Service Bulletin

Bulletin No.: 13-06-02-001

Subject: Supplemental Repair Required for Drive Motor Battery Coolant Radiator Replacement Due to Stone/Foreign Material Impact

Models: 2011-2013 Chevrolet Volt

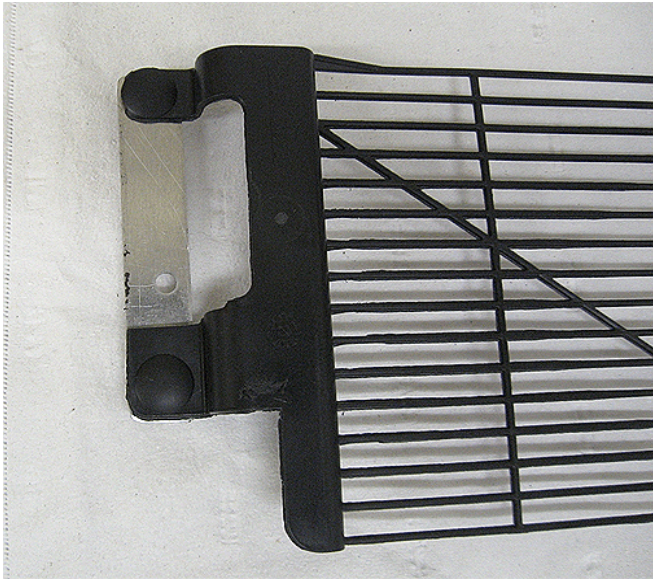
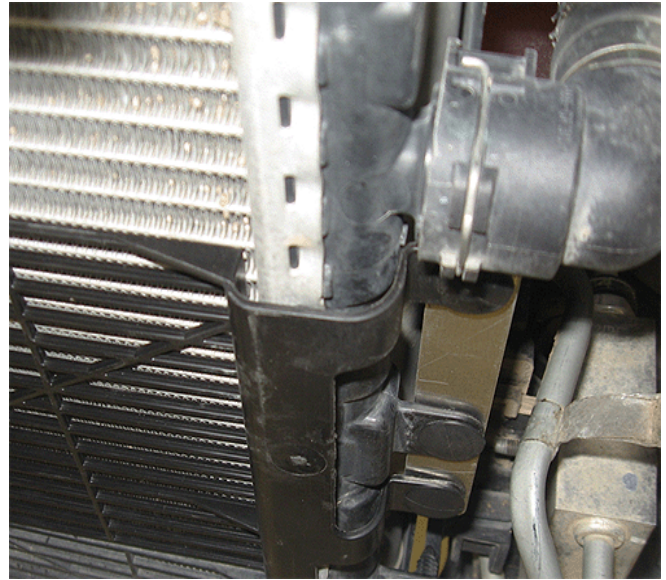
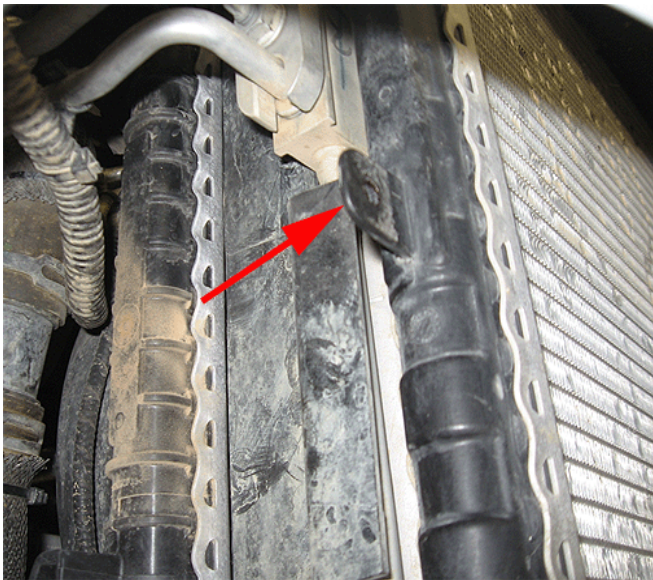
3. Fabricate two mounting brackets for the additional screen using 25 mm (1 in) x 100 mm (4 in) aluminum stock with thickness between 1.59 mm (0.0625 (1/16) in) and 3.18 mm (0.1250 (1/8) in). This material can be obtained locally. A good source for this material is Home Depot. The Home Depot carries Everbilt 1 in. x 36 in. Aluminum Flat Bar with 1/8 in. thickness, Model #44690 (Home Depot Canada carries H. Paulin - Model #142-642).
4. Remove any burrs on the cut surface(s) and round the corners using a file.

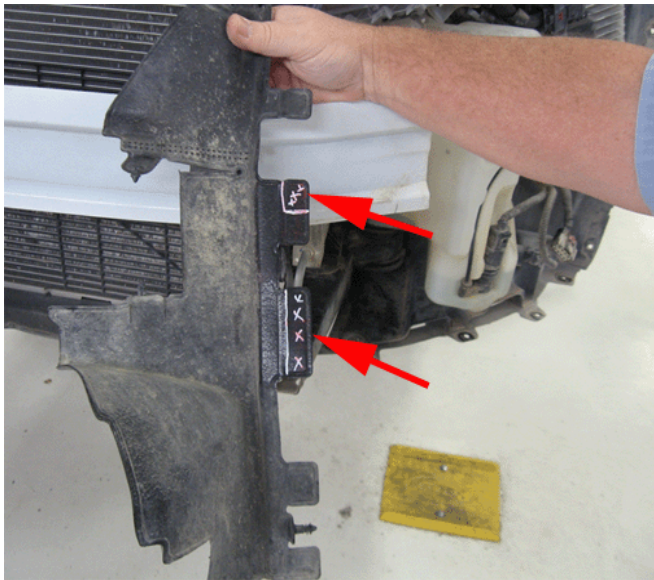
5. Using the grille screen mounting tabs as the template, drill holes as shown using a 6.25 mm (0.250 in) drill bit.
6. Mount the brackets to the screen using the retainers.

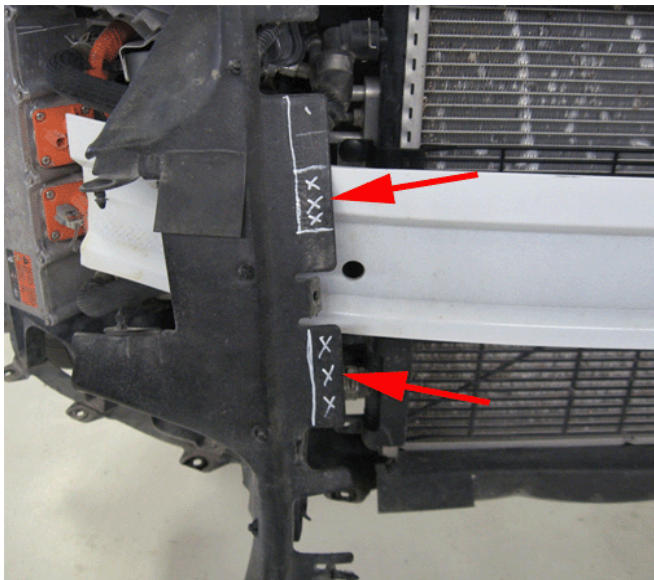
7. Place the grille screen with mounting brackets attached on the new radiator above the existing screen. Align the screen so that the tubes on the radiator are covered and mark the hole locations that will attach to the existing tabs at each end of the radiator.
8. Drill the holes as marked using a 6.25 mm (0.250 in) drill bit.
9. Install the grille screen to the new radiator using the retainers.
